ADDENDUM NO. 2

BUFFALO AND ERIE COUNTY BOTANICAL GARDENS ADDITION
Erie County DPW Project #2022-903-02
Wendel Project #605802

03-06-2025

A101

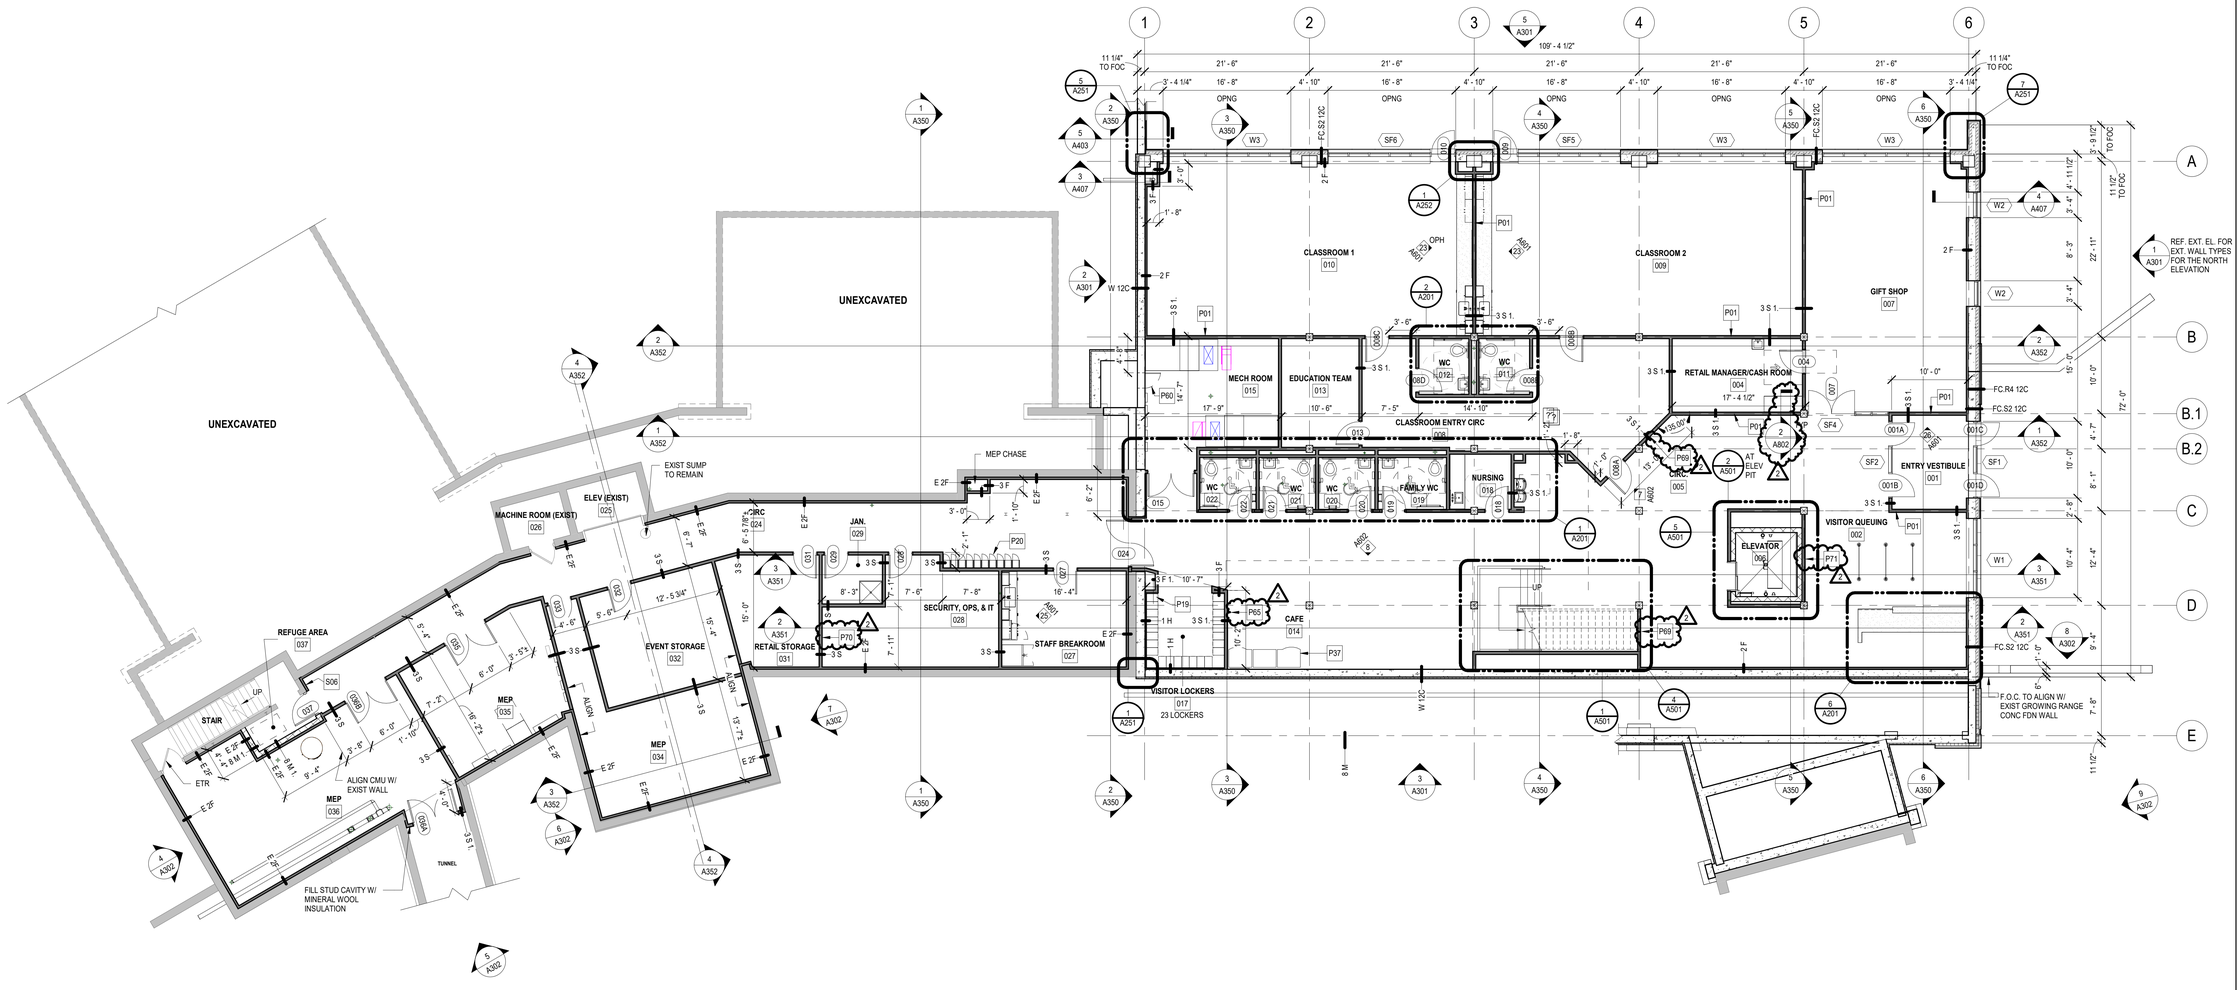
Keynote added for OFOI Coffee Maker location.
Section marker added to counter in Retail Manager Room 004
Keynote P69 added at locations of OFCI TVs to clarify blocking requirements.
Keynote P70 added at OFCI data rack location in Security Room 028 to clarify blocking requirements.
Keynote P71 added at OFCI Ticketing Kiosk location to clarify blocking requirements.

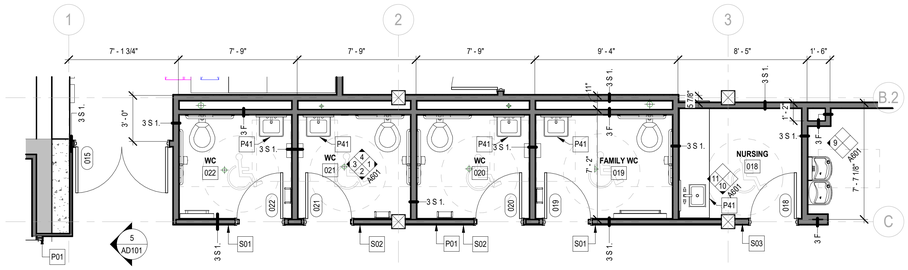
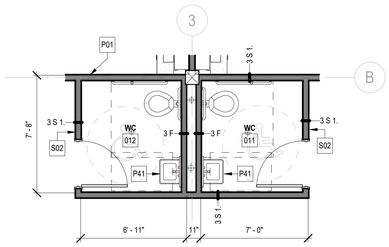
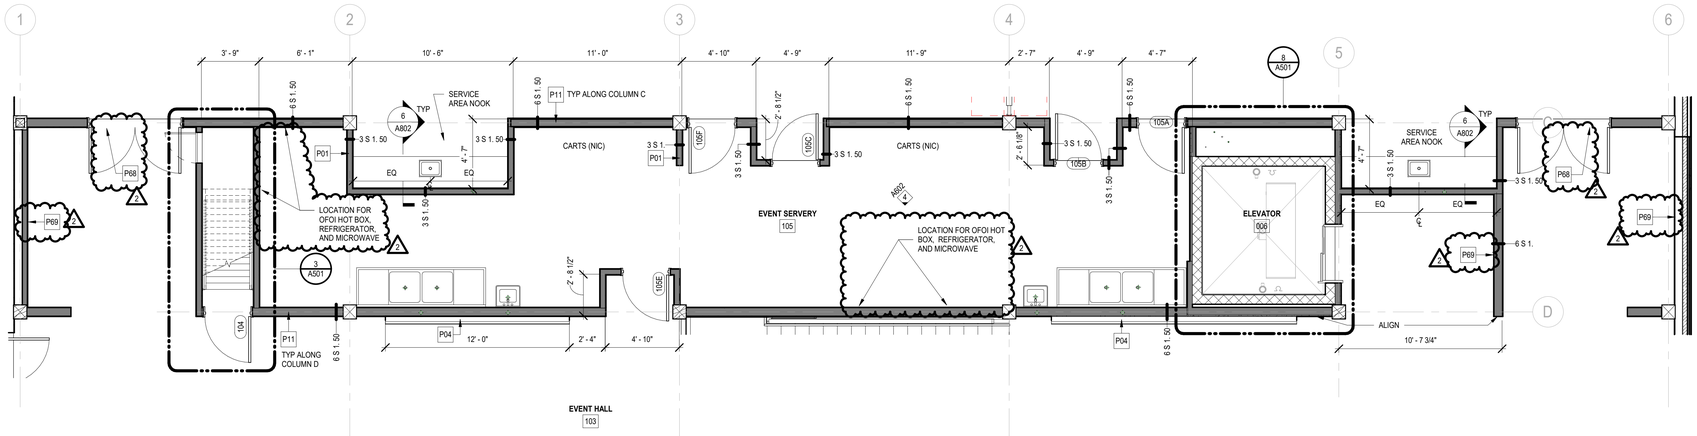
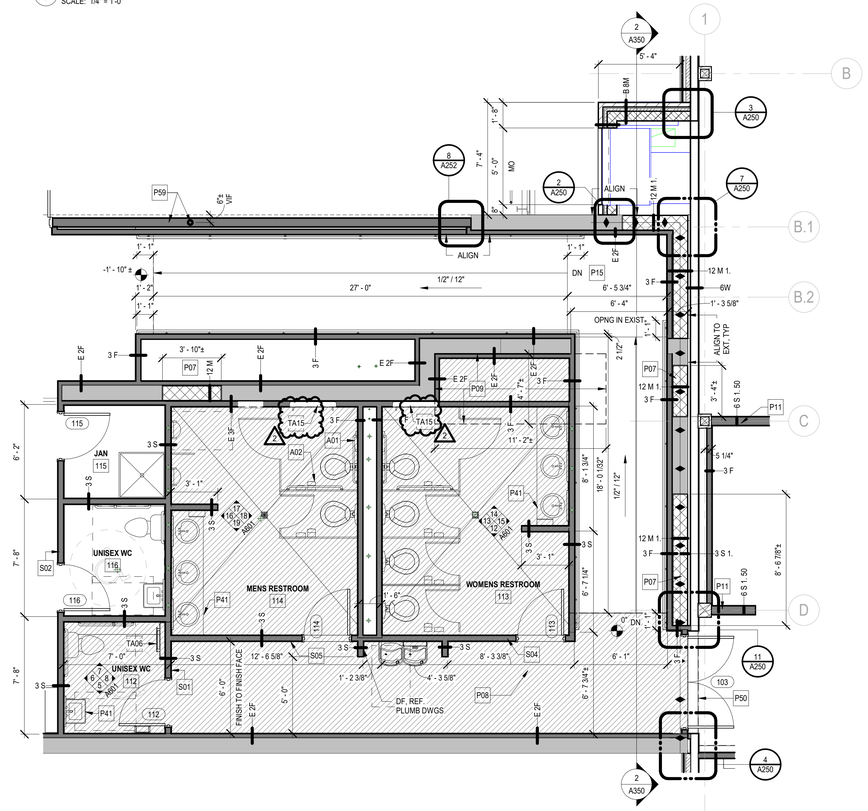
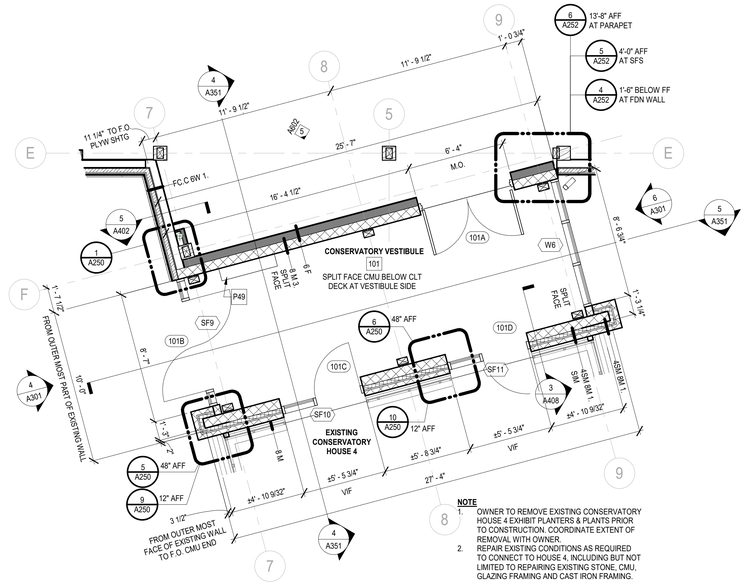
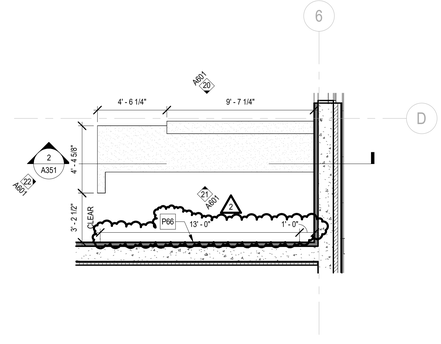
Enlarged Plan 6: Dimensions and Keynote added for OFCI wall-mounted TVs and associated blocking.
Enlarged Plan 3: Annotation added for clarification regarding OFOI equipment in Event Servery 105.
Enlarged Plan 3: Keynote P68 and P69 added at locations of OFCI TVs to clarify blocking requirements.
Enlarged Plan 4: Keynote TA15 added for clarification at OFCI baby changing stations.

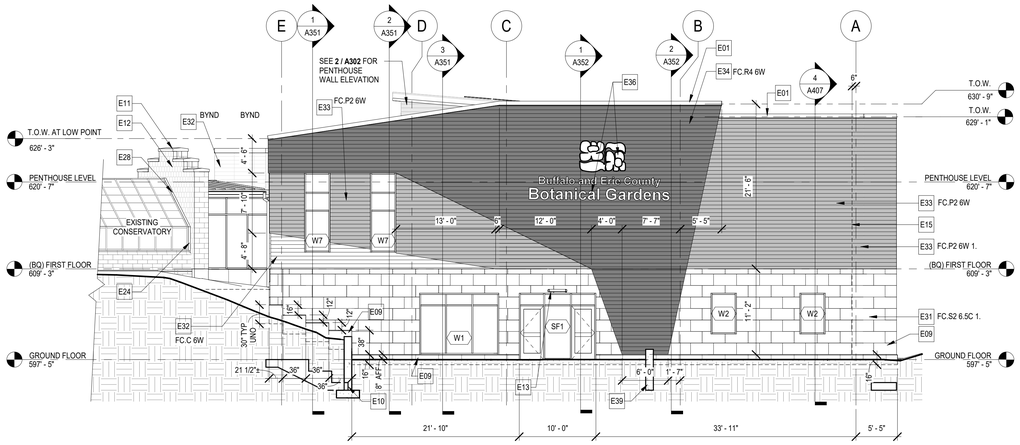
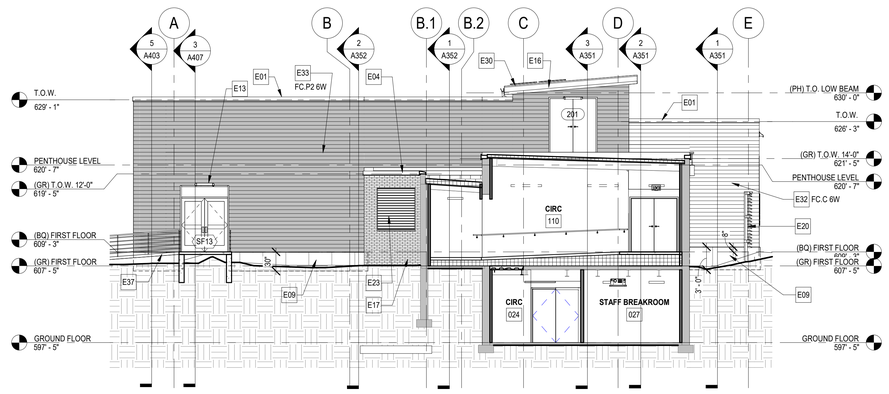
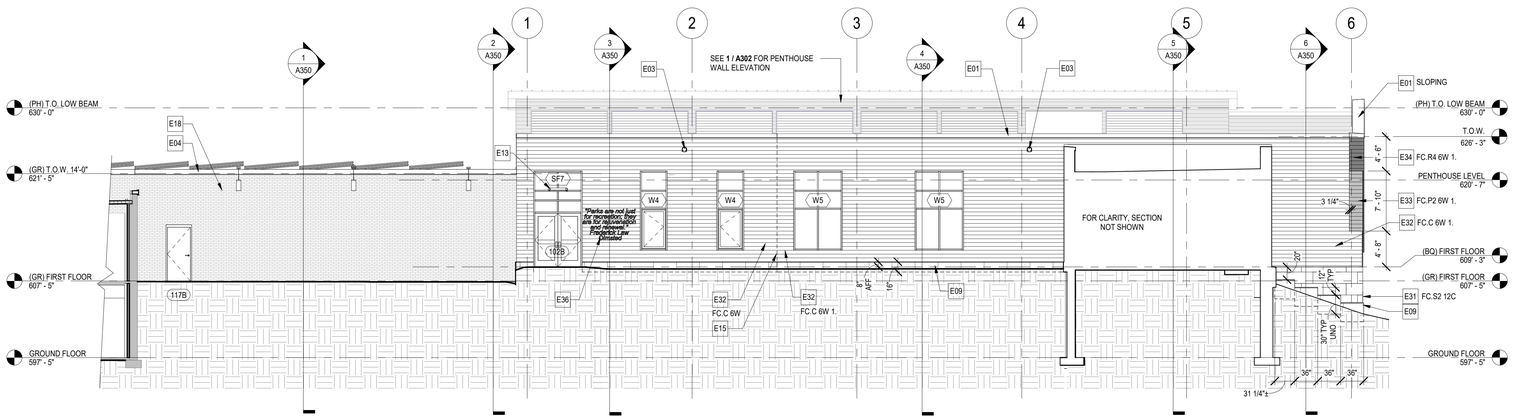
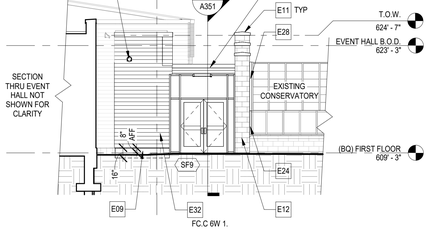
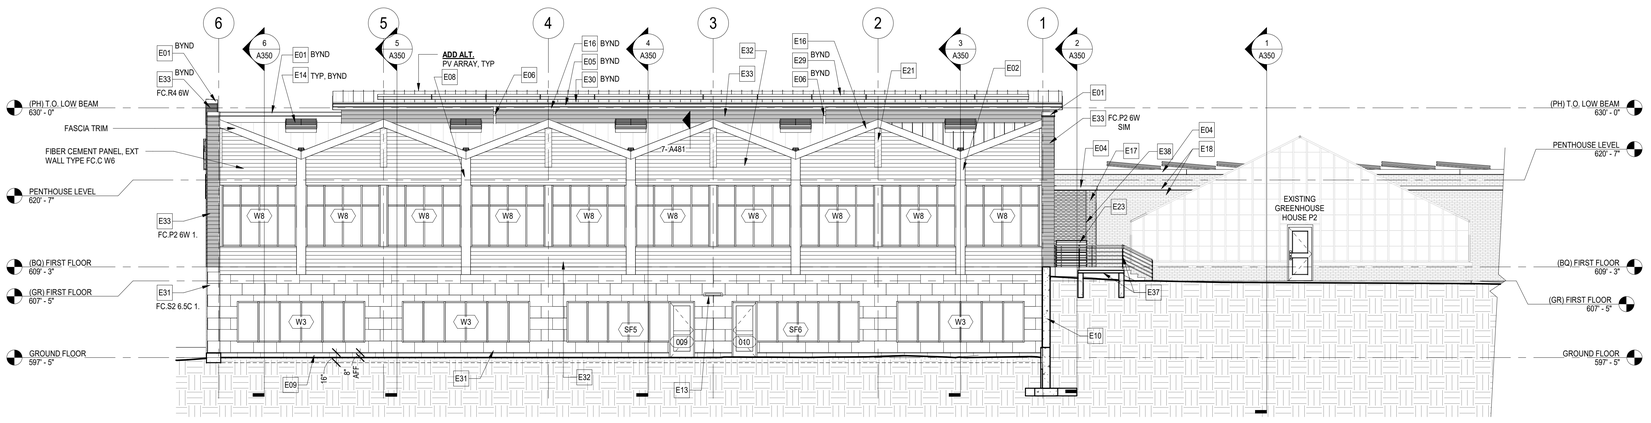
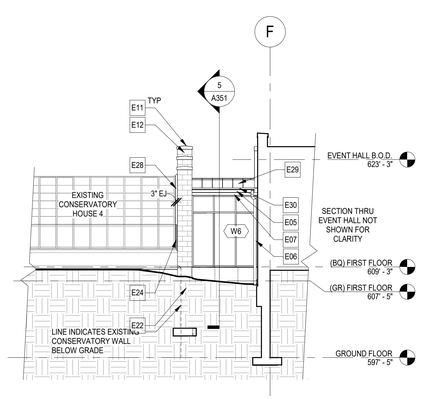
Keynote E36 revised for exterior signage clarification.

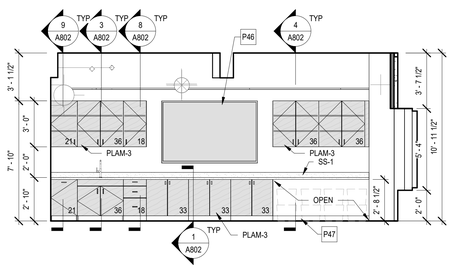
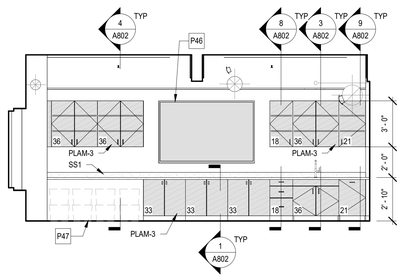
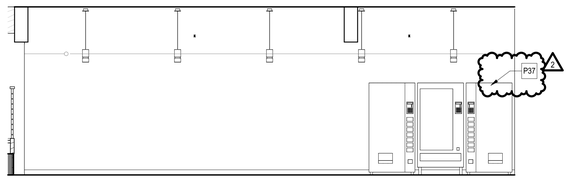
OFCI Clarification added to Keynotes for surface mounted changing stations.
OFCI Clarification added to Keynote for flip-down child protection seat.
Interior Elevation 25: Keynote added for OFCI Refrigerator.
Interior Elevation 25: Keynote added for OFCI Microwave.
Interior Elevation 29: Keynote added for OFOI Vending machines.

A602 ELEVATION KEYNOTES

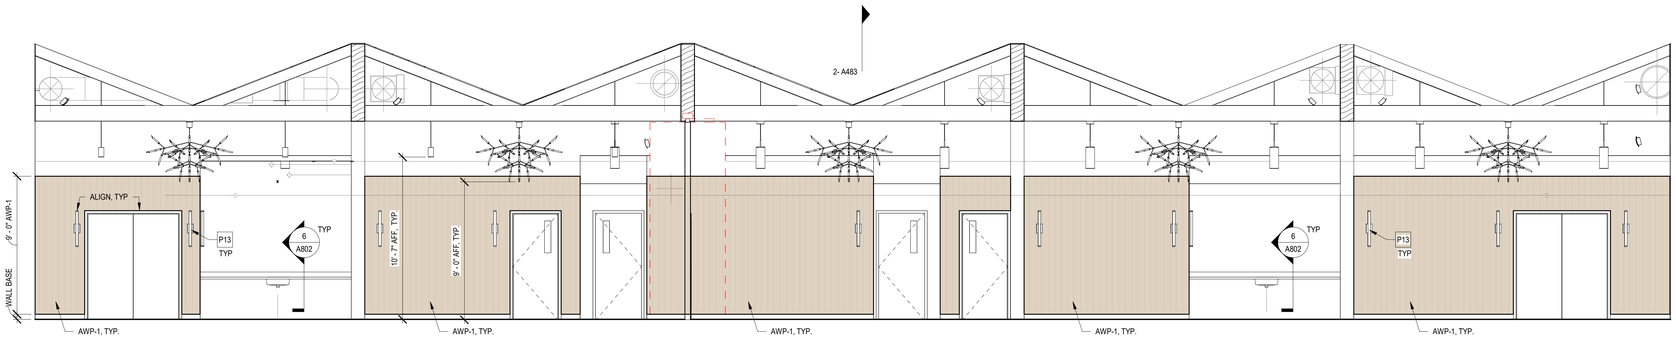
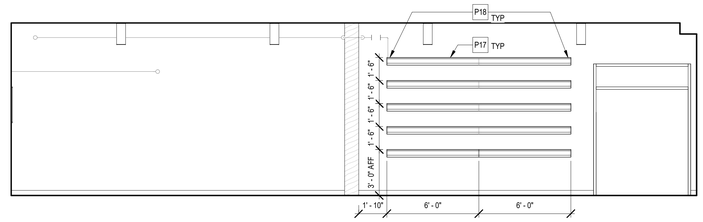
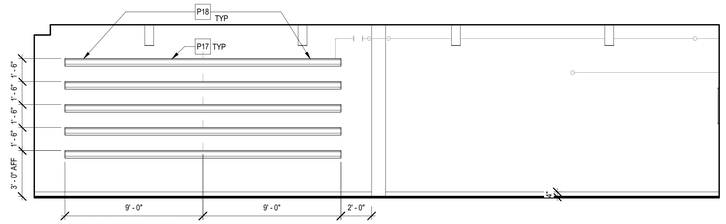
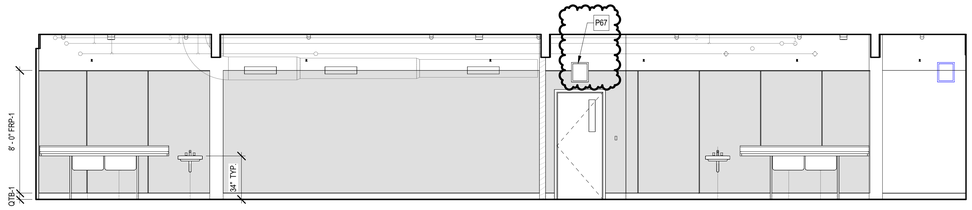
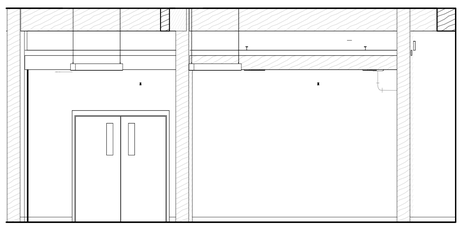
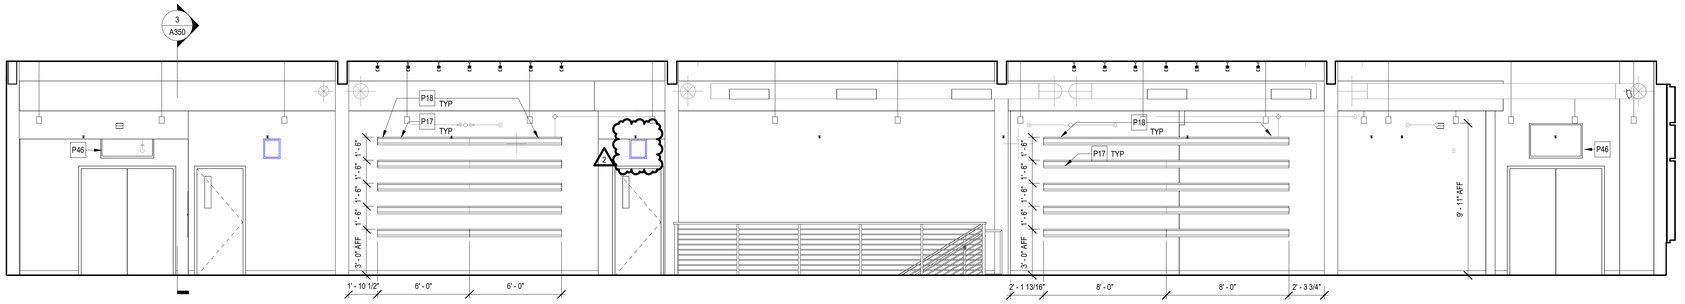
Location of through-wall mechanical transfer grille updated and new keynote P67 added for clarification.
